MODIFICATION RECOMMENDED

6812B-04

S E R V I C E N O T E

6812B AC SOURCE/ANALYZER, 0-300 VRMS, 750 VA, SINGLE-PHASE. GPIB, RS-232.

Figure 3 Regal Non locking Nut

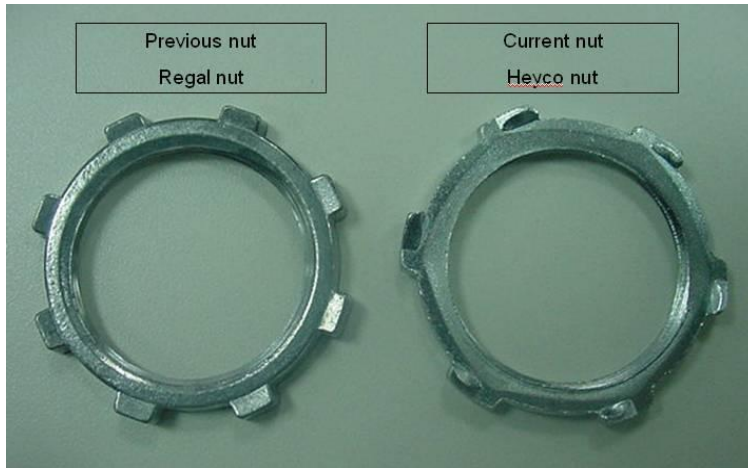
Figures 3 & 5 is representative of a not without locking ribs.

Figures 4 & 6 is representative of a nut with locking ribs.

The entire AC **INPUT SAFETY COVER** P/N 5040-1676 should be replaced.
